**Addendum #1**

Addendum Date: December 3, 2024

Project: Swift Community Center

ELECTRICAL DEMOLITION PLANS

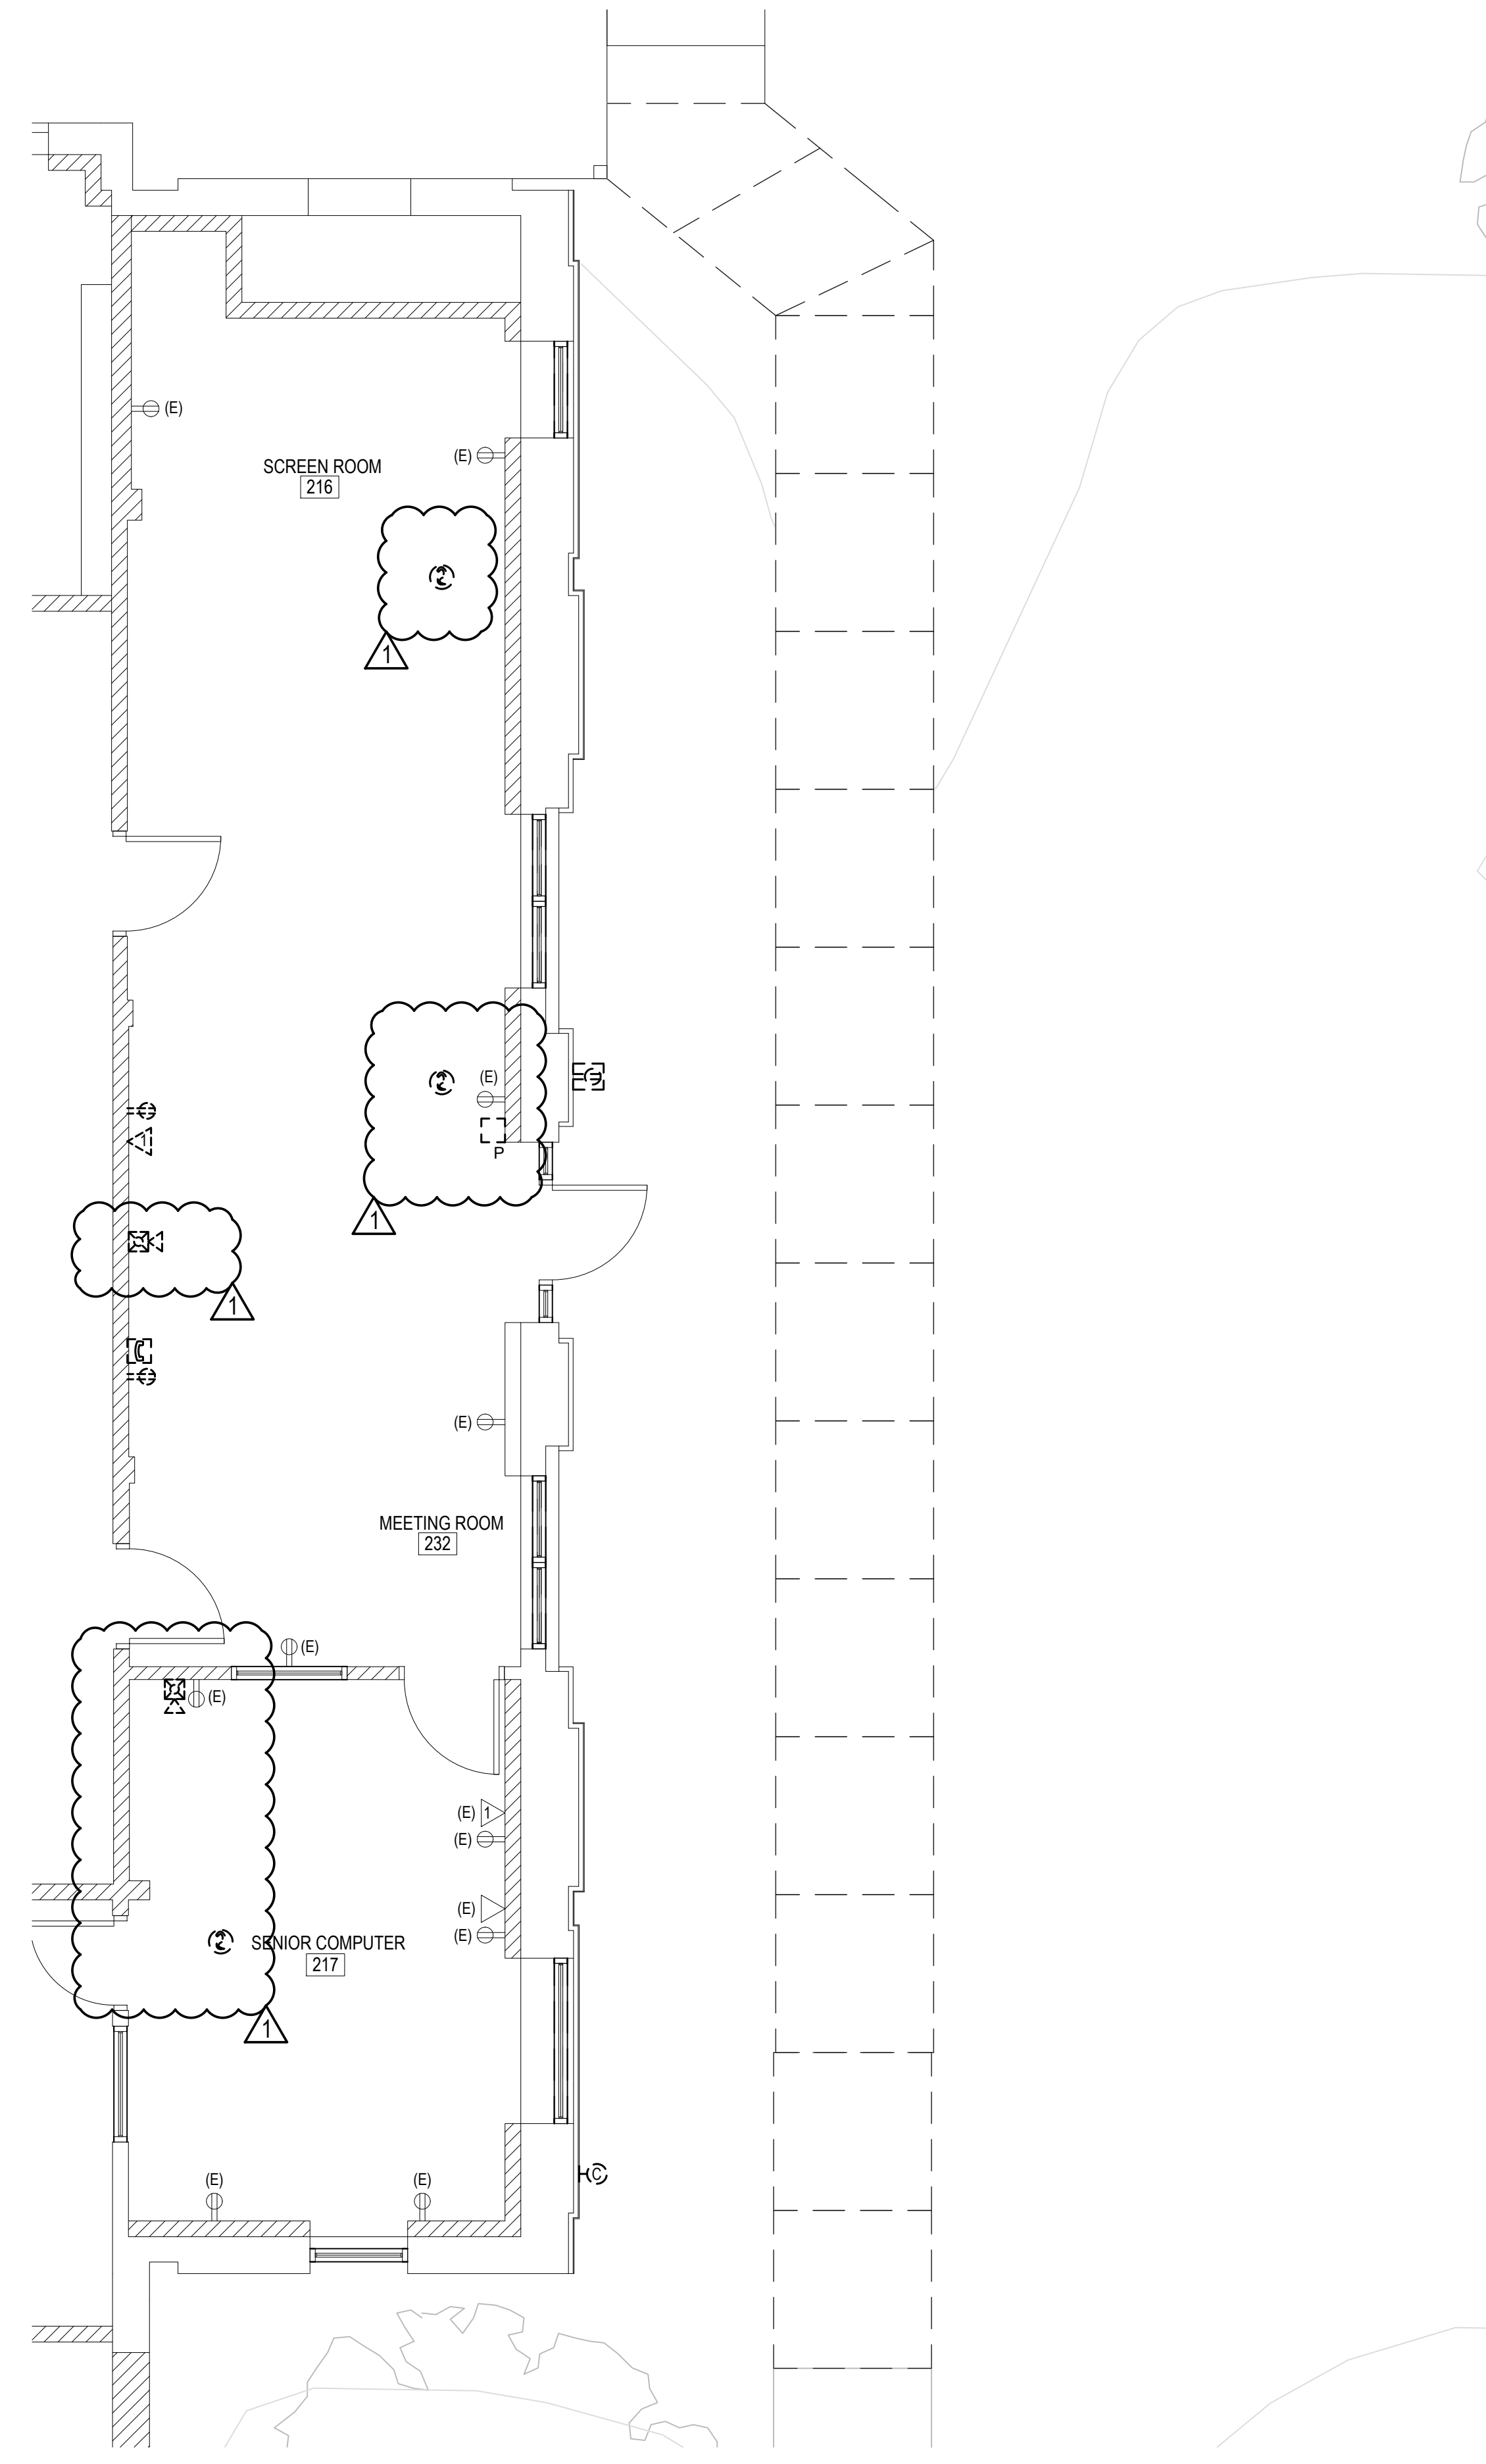
1. E-000
  - a. Added fire alarm devices to the symbol legend.
  - b. Added a Fire alarm system description.
2. ED101
  - a. Added fire alarm devices to be demolished.
3. E-101
  - a. Added new fire alarm devices.
  - b. Revised the location of the new electrical panel PL1A to the adjacent wall with the storage room.
4. E-600
  - a. Added a circuit breaker for the added NAC panel.
  - b. Revised the description of PL1A-18.
5. M-101
  - a. General notes added
6. M-500
  - a. Diffuser and return grille schedules updated to reflect drawings.

ELECTRICAL PLANS

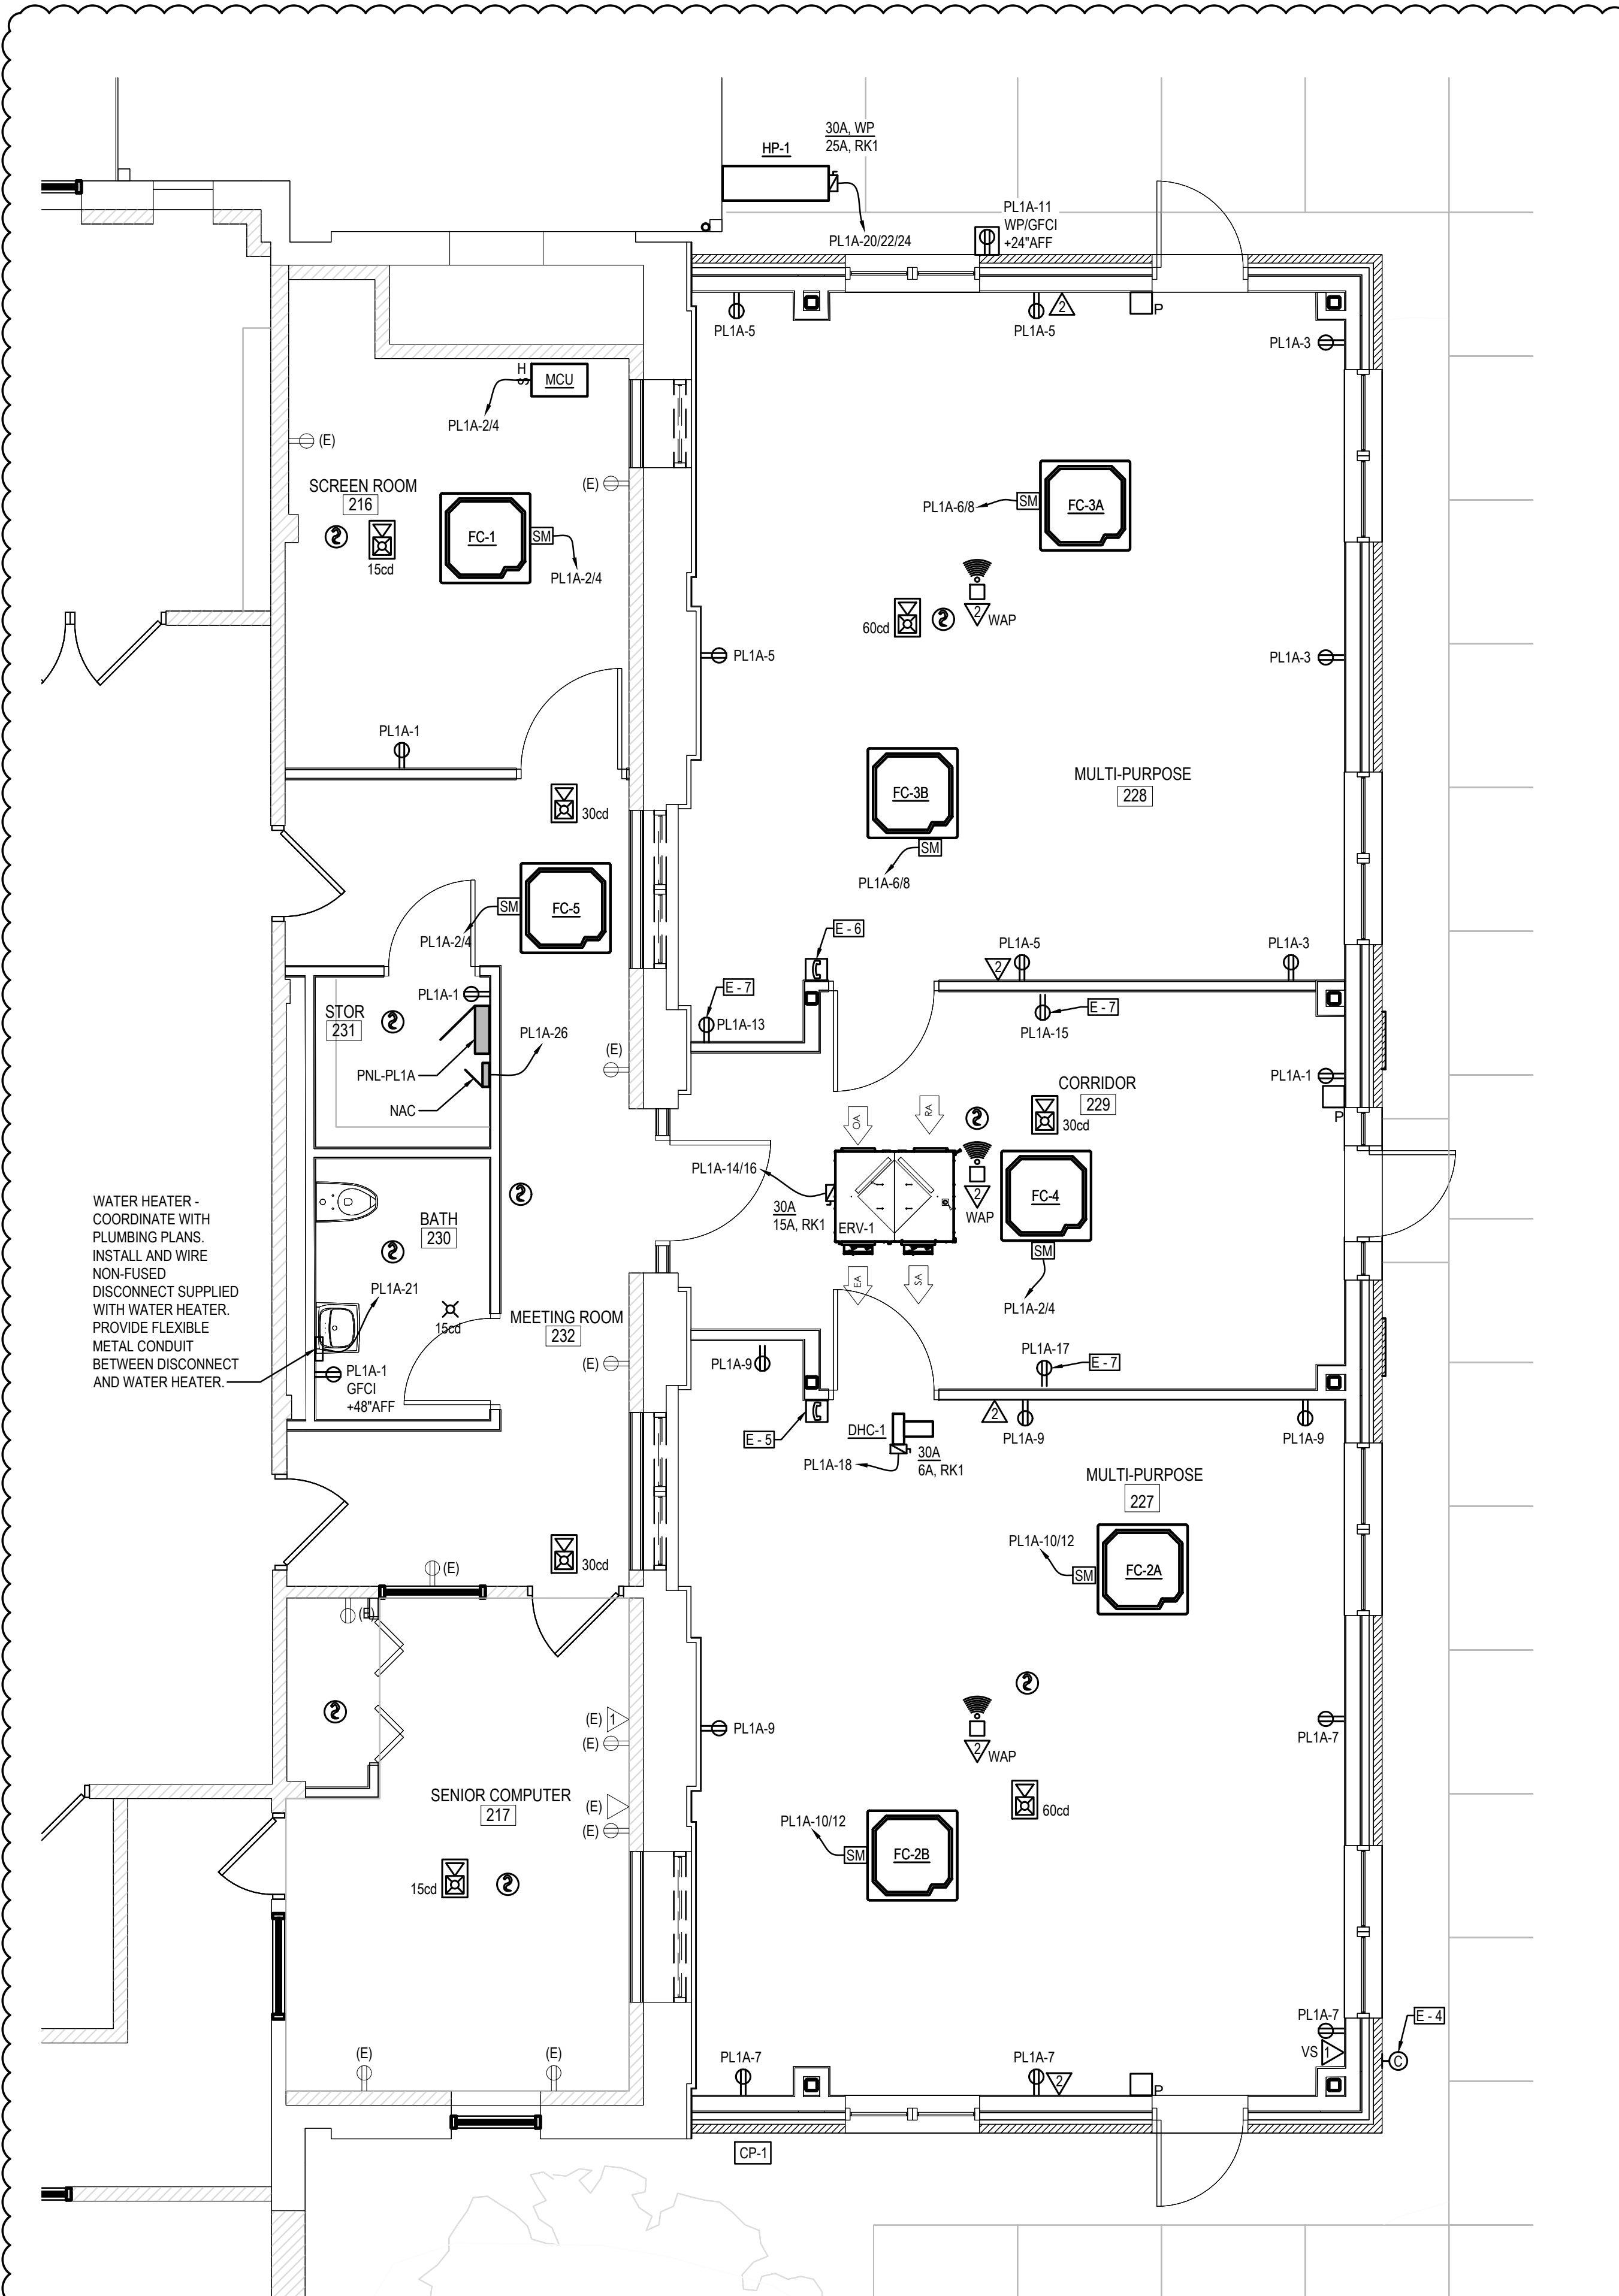
**Q18.** Panel PL1A circuit #18 description "DHC-1 - Corridor 229". Please confirm this should be "DHC-1 - Multi-Purpose 227" as shown on drawings E-101 and M-101. Or is there a 2nd DHC-1 unit?

**A - PL1A-18 is labeled incorrectly and should be DHC-1 - Multi-Purpose 227. This will be corrected in Addendum #1.**
